CITY OF PORTLAND, MAINE

Re: Upper A Street, Peakes Island

Your application to replace deck has been reviewed and a permit is herewith issued subject to the following requirement:

BUILDING PERMIT REPORT

Karlsen House

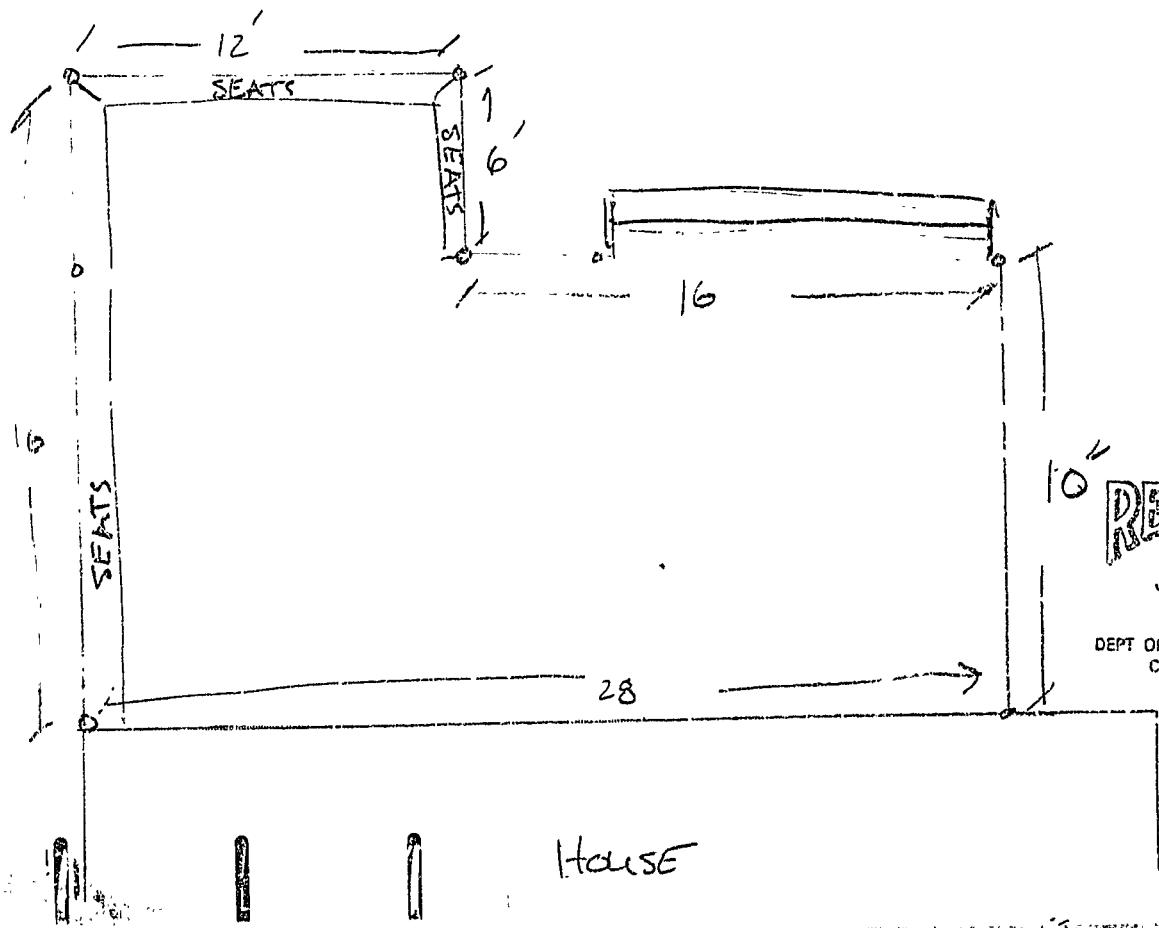
*7.) A guardrail system located near the open side of deck or elevated walking surfaces shall be constructed. Guards in buildings of Use Group R-3 shall be not less than 36 inches in height. Open guards shall have intermediate rails, balusters or other construction such that a sphere with a diameter of 6 inches cannot pass through any opening.
